## Vanguard 7300 Series Hardware Advisory Notice T1/E1/PRI Card Release 6.5.T10A

### Vanguard 7300 T1/E1/PRI Card Upgrade

**Figure 1: Revision Identifier Label**

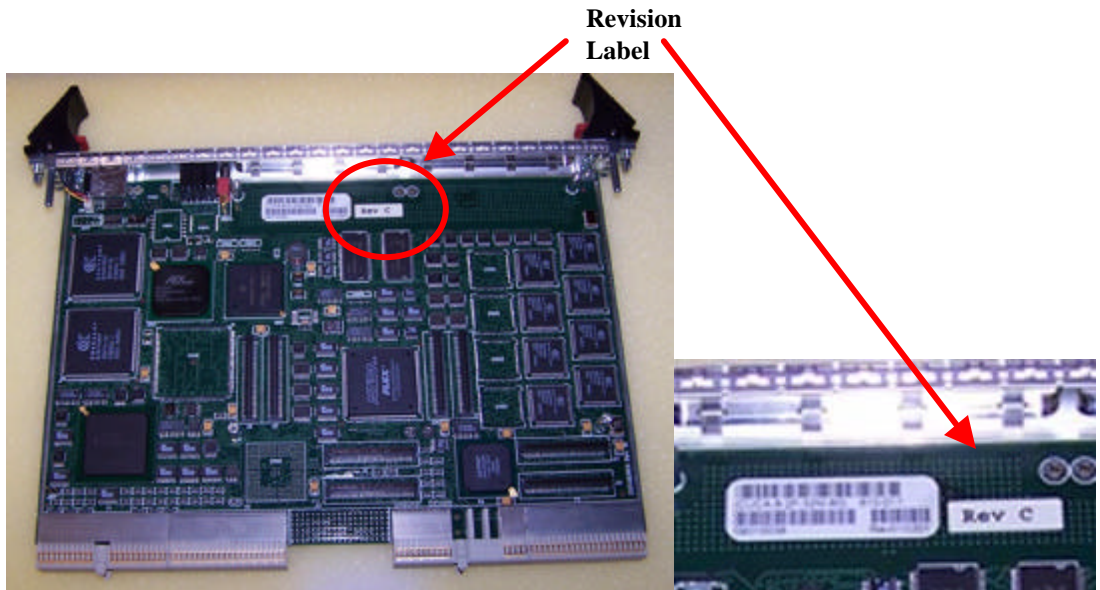
The arrows in Figure 1 show the location of the revision label, which identifies whether the T1/E1/PRI card is Revision C.
